SUBJECT: Forwards addl info in response to NRC 800728 ltr re
 containment ventilation isolation. Three oversize electrical
 drawings encl. SEE DRAWINGS

Re: Turkey Point Units 3 & 4
Docket Nos. 50-250 and 50-251
Containment ventilation isolation

Re: Turkey Point Units 1 & 4
Docket Nos. 50-250, 50-251
Containment ventilation isolation

BECHTEL CORPORATION
GAITHERSBURG, MARYLAND
FLORIDA POWER & LIGHT COMPANY
TURKEY POINT NUCLEAR UNITS
UNIT NO. 3 1970-790 MW INSTALLATION
UNIT NO. 4 1971-790 MW INSTALLATION
CONNECTION DIAGRAM
MISCELLANEOUS EQUIPMENT
DATE 4-10-70
DRAWING NO. 5610 E-389
sh 1 of 1 F-502706

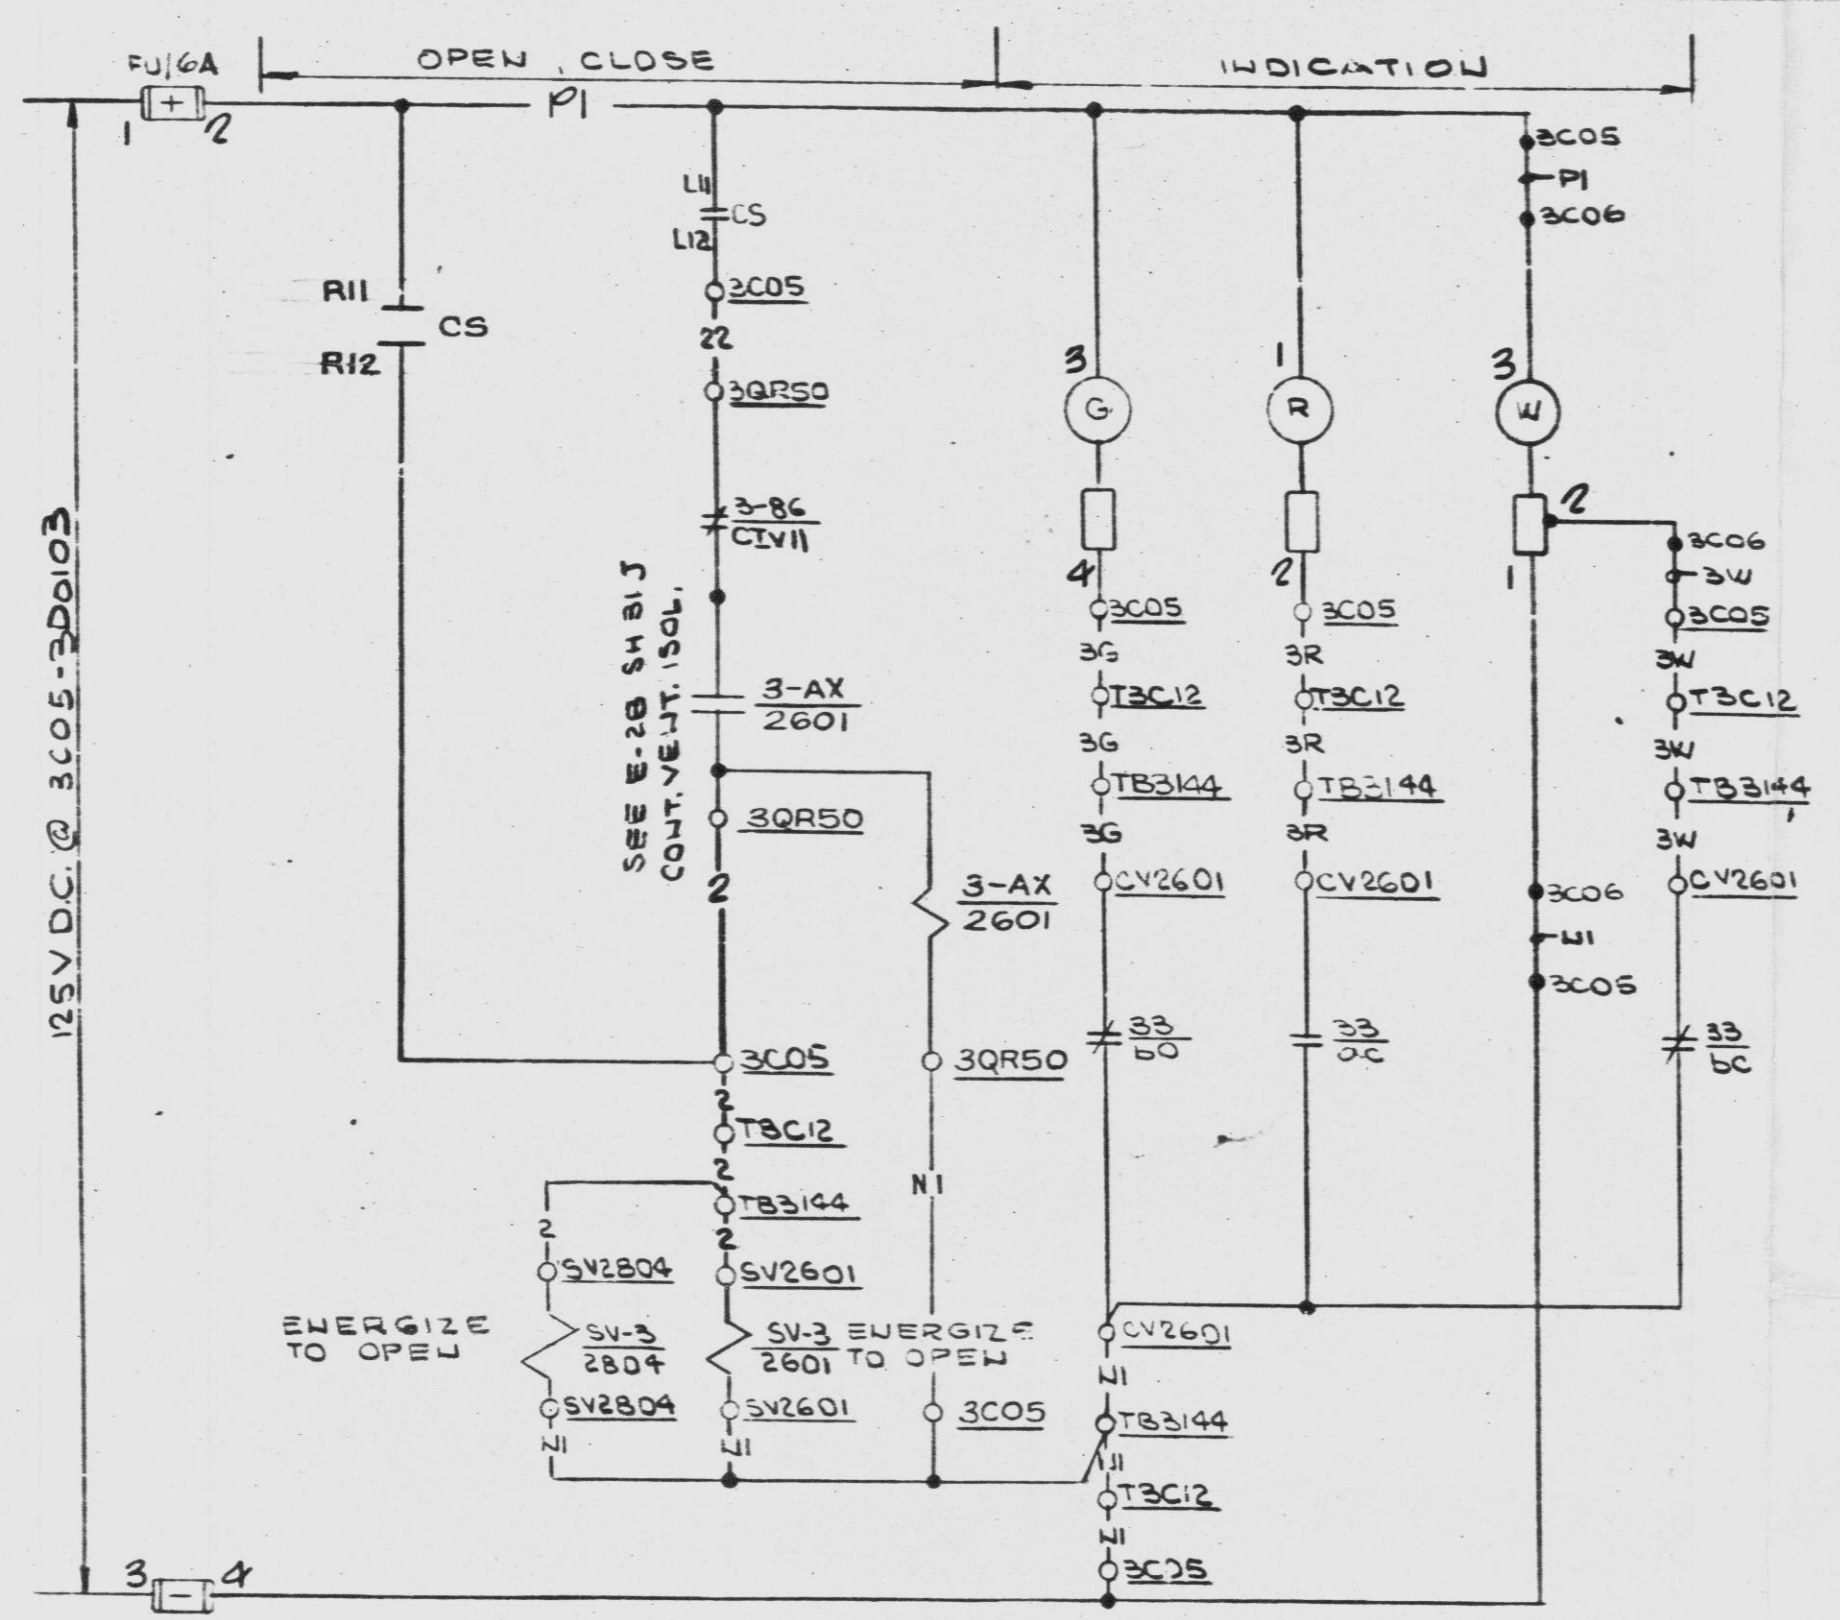
What is the memory element in the CVI control circuit shown on FPL drawing 5610-T-L1? Is it an MG-6 relay? Shown on what drawing? Please send drawing. Also, please send drawings 5610-E-25, sheet 59, E-389, and lesson 45. What is the form of switch QR50? Momentary? Key lock?
